CPED STAFF REPORT

Prepared for the City Planning Commission
CPC Agenda Item #5
August 3, 2015
BZZ-7228

Project Name: Temple Israel Education and Lobby Expansion

1 ELECTRICAL SITE PLAN

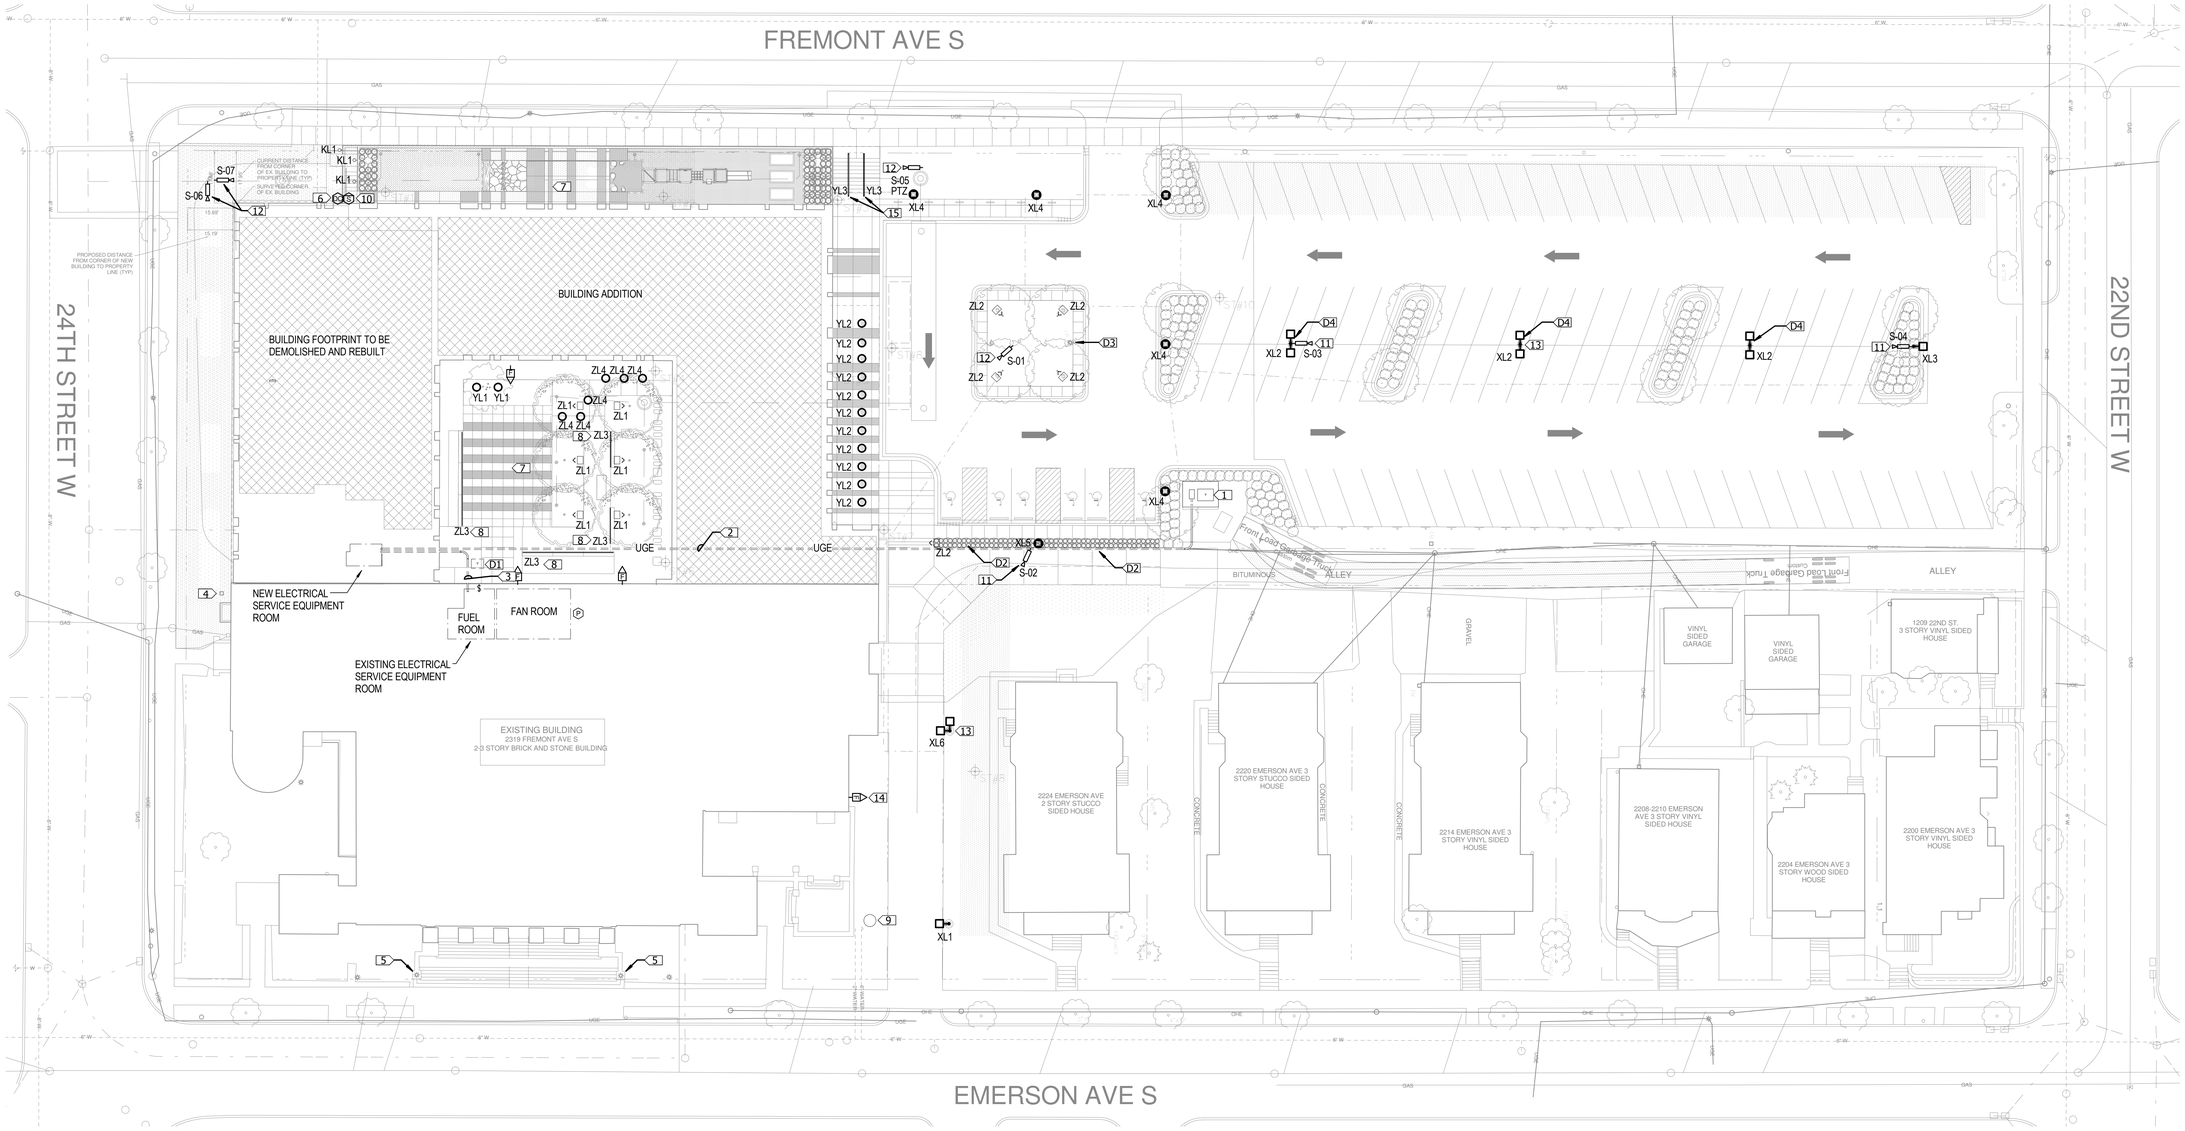
- The applicant is proposing to install pole mounted LED light fixtures within the parking lot, decorative lighting on the exterior of the building including up-lighting as well as the incorporation of wall mounted lighting on the building. A photometric plan was submitted as part of the application and will be required with the final submittal. Adjustments to the lighting plan will need to be made in order to eliminate spillover onto adjacent properties. Lighting of building façades or roofs shall be located, aimed and shielded so that light is directed only onto the façade or roof. All lighting will need to be downcast and shielded to avoid undue glare. All lighting shall comply with Chapters 535 and 541 and CPED Staff shall review the details of the fixtures in the final review prior to permit issuance. Details are provided on Sheets E030 and E031.
